## SERVICE BULLETIN REFRIGERATOR

**MODEL:** SJF60PCSL/WH, SJF60PSSL, SJF60PVSL, SJF602SPSL/BK, SJF65PCSL/WH, SJF65PSSL.

**SUBJECT:** Countermeasure for frozen damper

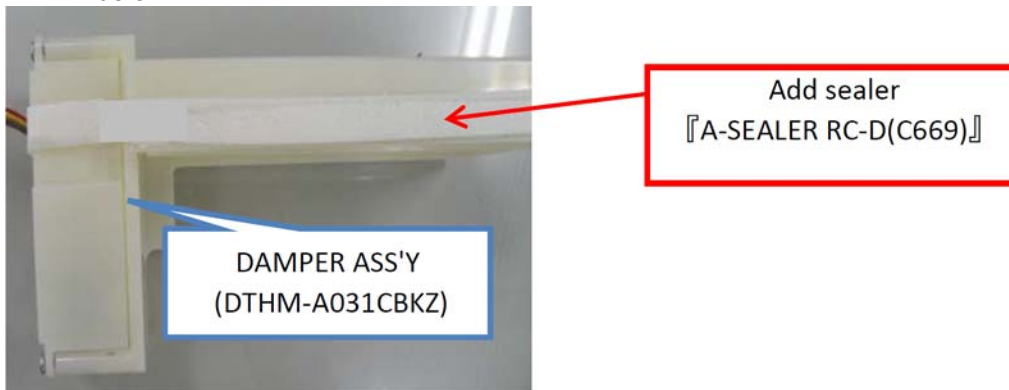
**GENERAL:** In some isolated cases there were some ice formed inside the damper gear box which cause the fridge operated out of specification.

**SYMPTOM:** Freezer too cold or fridge not cold.

**CAUSE:** Frozen damper.

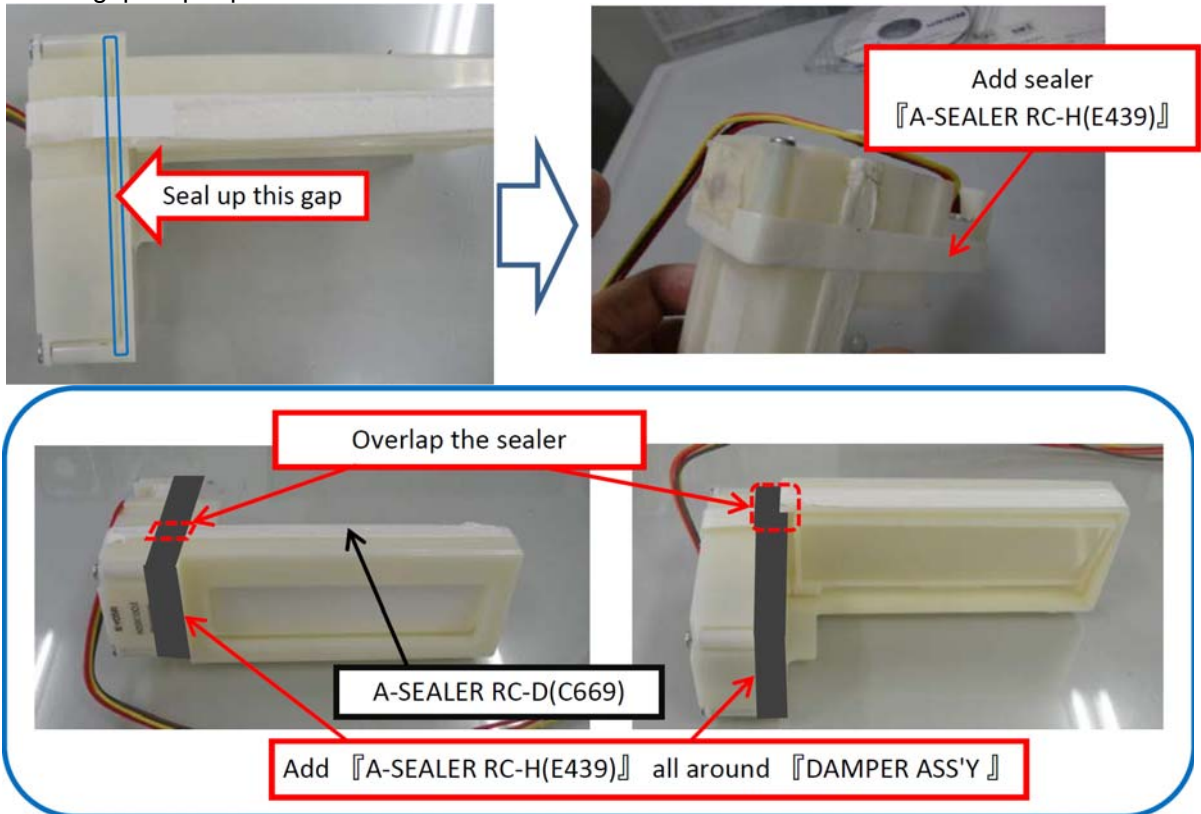
- 1) Please replace the damper assy part number DTHM-A031CBKZ because some water may remain inside the old damper assy.
- 2) Add sealer RC-D part number PSEL-C669CBZZ around the damper assy as per photo below:
